Access Compliance Report

Public Rights-of-Way

Intersection ID: 25632	Main Street: RAINTREE_LN	Cross Street: WINDBLUFF_DR	Location:	SW
ADA ID: 01C0D74704B9	Ramp Type: Perp	Initial Pass/Fail: Fail	Overall Compliance: No	Severity Score: 25

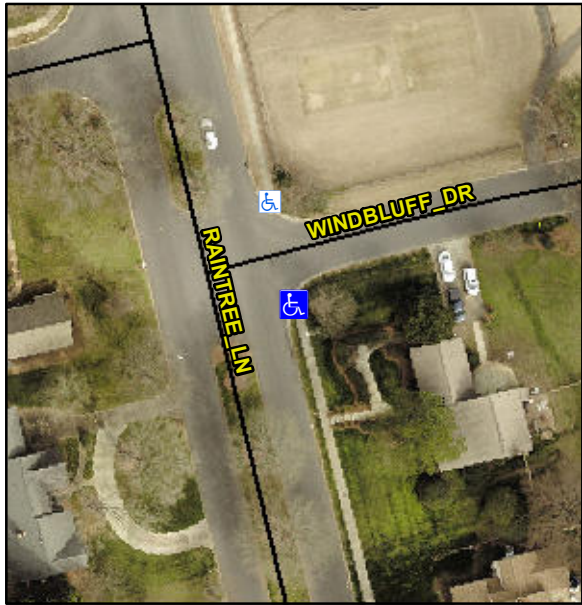
Codes/Mitigation Info/Possible Solution			Field Measurements/Component Compliance					
	Possible Solutions:		Compliance	Description	Data	Compliance	Description	Data
	Remove & Replace Entire Ramp.		N/A	Ramp Length (in)	24.5	Yes	Ramp Slope (%)	6.1
			Yes	Ramp Width (in)	48.0	No	Ramp XSlope (%)	8.6
			N/A	Flare Type LT	N/A	N/A	Flare Type RT	N/A
			N/A	Flare Slope LT (%)	N/A	N/A	Flare Slope RT (%)	N/A
			N/A	Flare Traversable LT?	N/A	N/A	Flare Traversable RT?	N/A
			N/A	Landing Length (in)	N/A	N/A	DWS Provided?	N/A
			N/A	Landing Width (in)	N/A	N/A	DWS Contrast?	N/A
			N/A	Landing Slope (%)	N/A	N/A	DWS Length (in)	N/A
			N/A	Landing X Slope (%)	N/A	N/A	DWS Full Width?	N/A
Surveyor Notes:			N/A	Landing Curb? (Y/N)	N/A	N/A	DWS Offset (in)	N/A
PROW/ADA:			N/A	Shared Landing?	N/A			
R304.5.3			N/A	Gutter Ponding?	N/A	N/A	Gutter Slope (%)	N/A
			N/A	Gutter Lip Ht (in)	N/A	N/A	Gutter X Slope (%)	N/A
			N/A	Painted X Walk1?	No	N/A	Painted X Walk2?	N/A
